2021/2526/P - 10 Charlotte Street, W1T 2LT

Delegated Report (Members Briefing)		Analysis sheet		Expiry Date:	16/07/2021
		N/A		Consultation Expiry Date:	18/07/2021
Officer				Application Number(s)	
Miriam Baptist				2021/2526/P	
Application Address				Drawing Numbers	
10 Charlotte Street London W1T 2LT				See Draft Decision Notice	
PO 3/4	Area Team Signature	C&UD	Authorised Officer Signature		
Proposal(s)					
The installation of two water tanks on the rear first floor roof.					
Recommendation:	Grant conditional planning permission				
Application Type:	Full Planning Permission				
Conditions or Reasons for Refusal:	Refer to Draft Decision Notice				
Informatives:					
Consultations					
Summary of consultation:	1 site notice was displayed near to the site on the 23/06/2021 (consultation end date 17/07/2021). The development was also advertised in the local press on the 24/07/2017 (consultation end date 18/07/2021).				
Adjoining Occupiers:	No. of responses	00	No. of objections	00

Proposal: The installation of two water tank modules on the rear first floor roof.

Figure A: Original & revised design respectively in context of rear façade of 10 Charlotte Street with the existing lantern in the foreground.

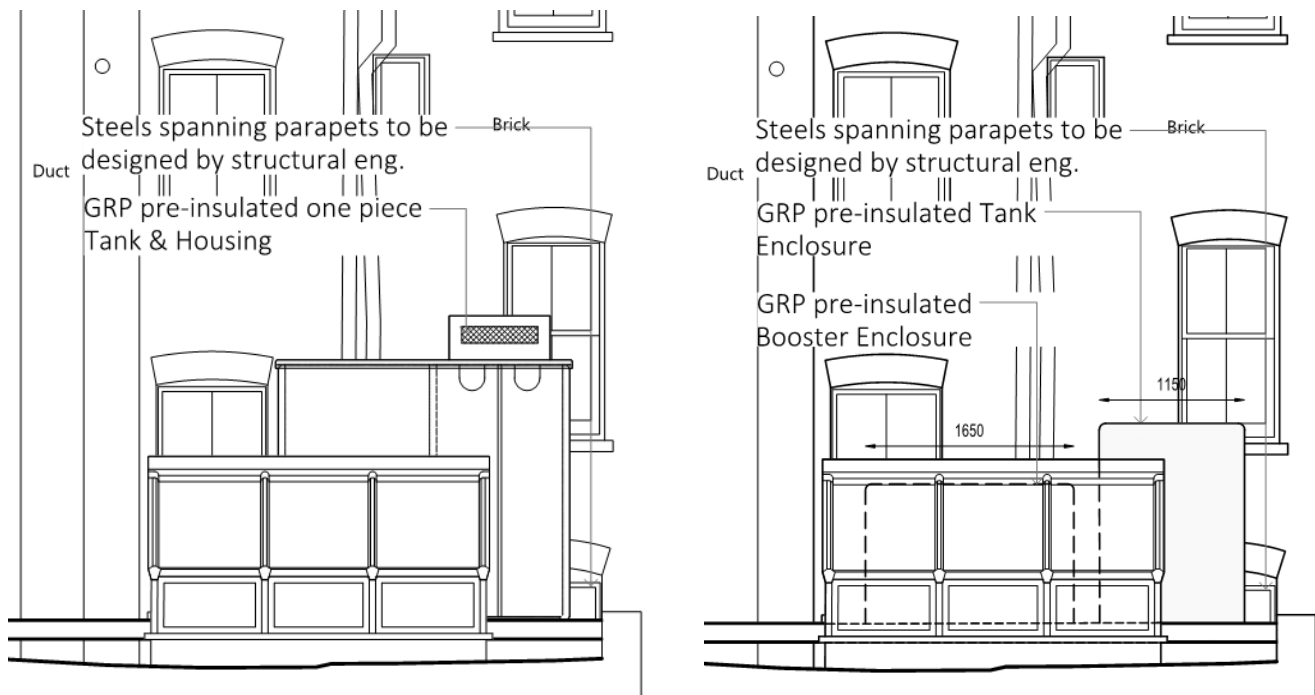
- 4.5. The revised two-component design takes the surrounding windows into consideration. There are three windows of the host building which are directly affected and must be considered in terms of present and future occupiers. Figure A shows the relationship of both the original design and revised design with the adjacent windows on the host building (N.B. existing lantern rooflight is shown in foreground). In relation to the revised design, the window behind the smaller enclosure is to a habitable room, and the two windows behind the taller enclosure are non-habitable rooms. The booster would be located in between the rear elevation and window at first floor level and, existing roof lantern. This would sit below the height of the roof lantern which would not result in additional obstruction beyond the existing situation.

- 4.6. The taller module would project just above the window cill level which is considered to have little impact on this window. There is also a small low-level window at extension's roof level which is a later addition to the rear elevation, and therefore of less importance to the hierarchy of openings. As stated both windows behind the larger module serve non-habitable rooms (storage room and staircase) and therefore no harmful impact to the existing standard of accommodation would be felt by occupiers.
